Rezoning Transportation Analysis
Petition Number: Insert Zoning Petition #2021-042
General Location Identifier: 14125107 & 14125108

Revision Log:	Date	Description
	04-29-2021	First Review (KP)
	05-27-2021	Second Review (KP)
	06-30-2021	Third Review (KP)

Transportation Summary

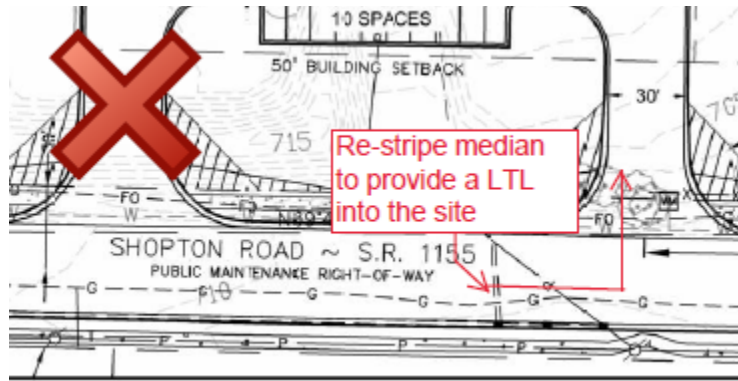
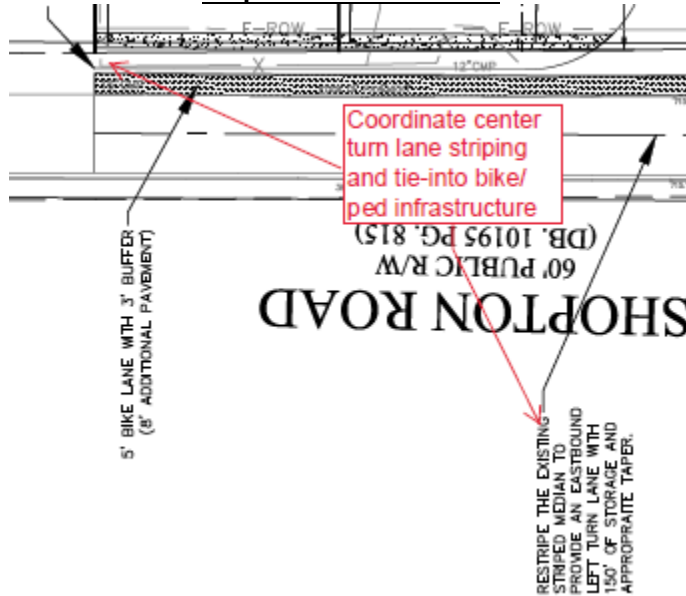
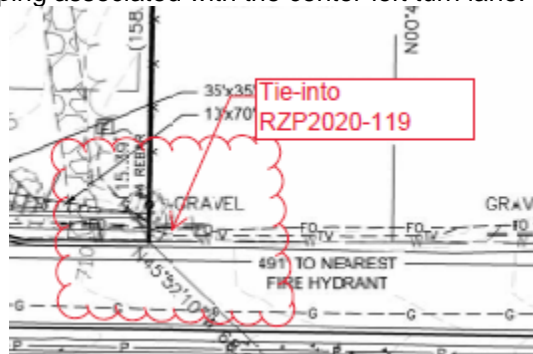
- 8. ~~Revise the site plan and conditional notes to commit to connecting the bicycle and pedestrian infrastructure, as well as the center left turn lane striping, into the previously approved infrastructure and striping associated with RZP 2020-119 adjacent to this petition. The infrastructure and striping will be designed and constructed in accordance with CDOT and NCDOT standards. Note: It will be beneficial to coordinate with 2020-119 as soon as possible to mitigate any unnecessary/redundant striping associated with the center left turn lane.~~
